UNITED STATES
DEPARTMENT OF THE INTERIOR
BUREAU OF LAND MANAGEMENT

FORM APPROVED
OMB NO. 1004-0135
Expires: July 31, 2010**SUNDRY NOTICES AND REPORTS ON WELLS**
*Do not use this form for proposals to drill or to re-enter an abandoned well. Use form 3160-3 (APD) for such proposals.***SUBMIT IN TRIPLICATE - Other instructions on reverse side.**

WELL NAME: Ottawa AOW Fed # 3 FIELD: Dagger Draw Upper Penn

Conditions of Approval

Wellbore schematics attached

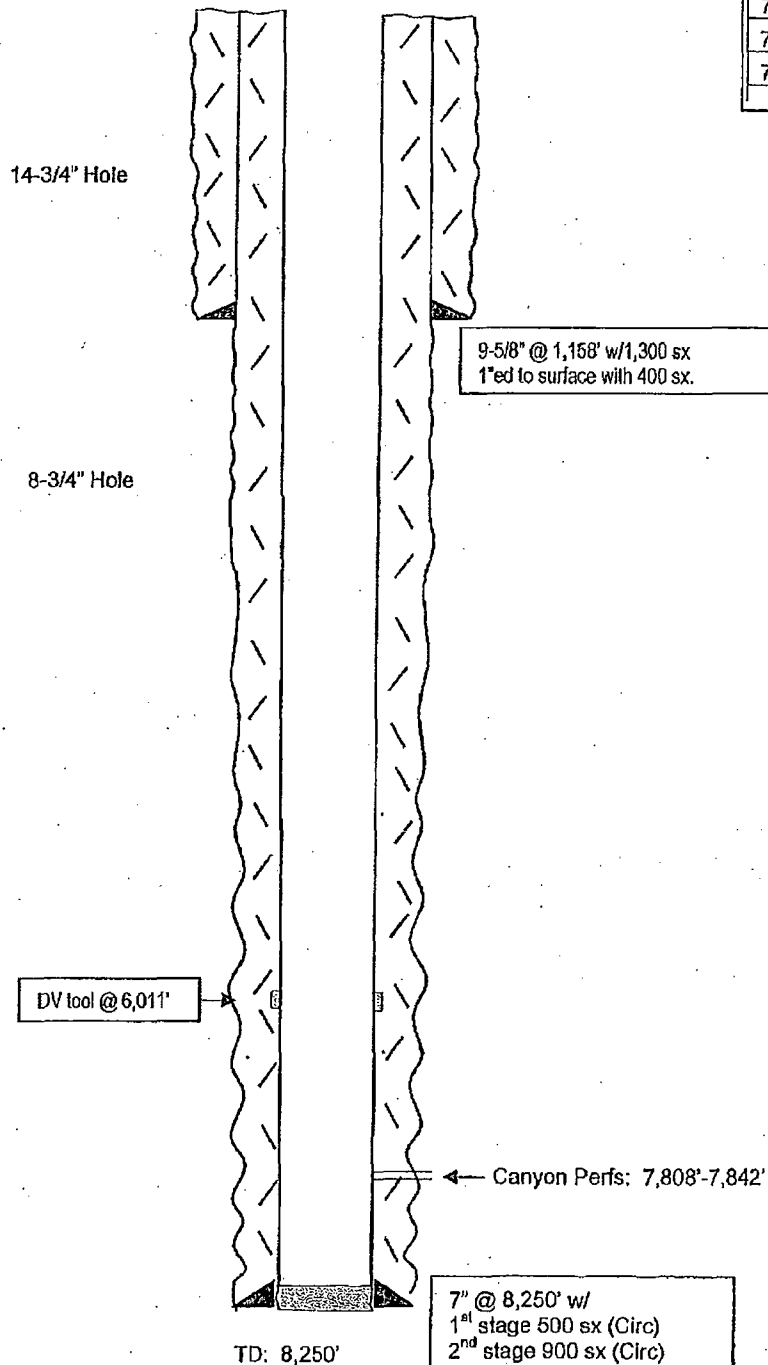
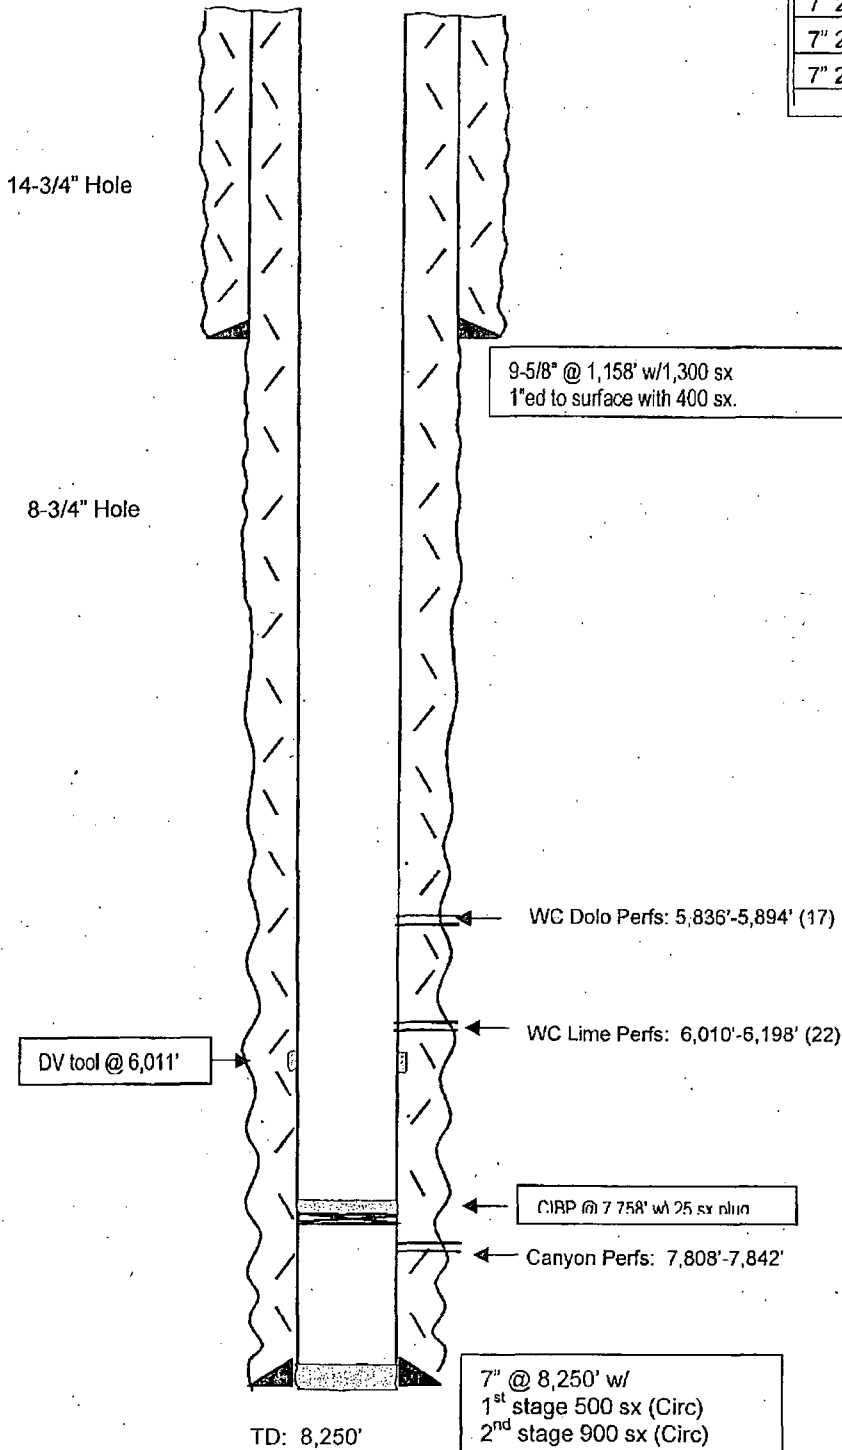
- 1. CIBP shall be set at 7758' (50' above the top perforation). A minimum of 35' of Class H cement shall be placed on top of the CIBP. Tag required.**

- 2. CIBP shall be set at 5960' (50' above the top perforation). A minimum of 35' of Class C cement shall be placed on top of the CIBP. Tag required.**
